MEMORANDUM

RE: Geotechnical Engineering Memorandum – **REVISED**
Sharma Retaining Wall Evaluation
7905 West Mercer Way
Mercer Island, Washington
NGA File No. 1496924

Figure 1

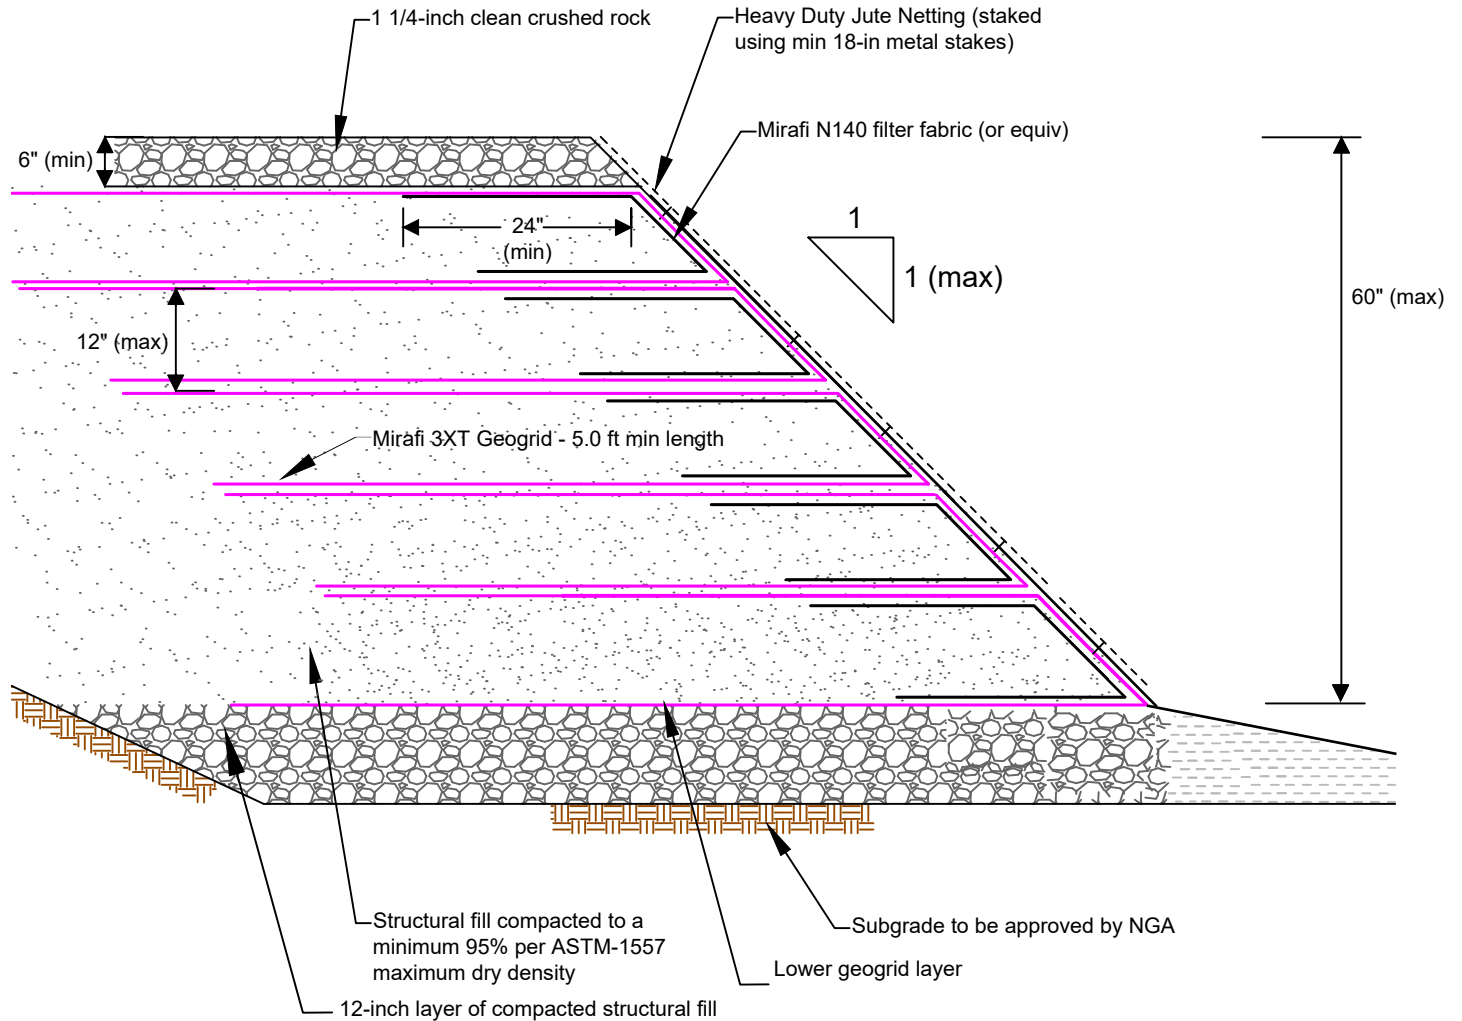
This memo presents our response to concerns raised by the City of Mercer Island regarding two utility easements located in the footprint of the proposed retaining wall at **7905 West Mercer Way on Mercer Island, Washington.**

A 10.0-foot-wide utility easement is located at the south end of the proposed wall. In this area, we would recommend a 1 Horizontal to 1 Vertical (1H:1V) reinforced slope be utilized instead of the originally proposed block retaining wall. The 1H:1V slope should be reinforced with **Mirafi 3XT geogrid wrap** lined with **Mirafi N140 filter fabric**, or equivalent. The surface of the slope should be covered with heavy duty jute netting staked in place with metal steaks that are a minimum of 18 inches long. The top of the slope should be covered with 6 inches of compacted 1¼-inch clean crushed rock. We recommend that the 1H:1V slope be founded on a 12-inch-thick layer of 1¼-inch clean crushed rock. A schematic of the reinforced slope is shown in Figure 1.

The toe of the 1H:1V slope may extend beyond the face of the wall. We recommend that the toe of the reinforced slope maintain a minimum separation of 3.0 feet from the top of the underlying rockery. This setback, combined with the 12-inch layer of crushed rock, should be adequate to prevent surcharging the rockery.
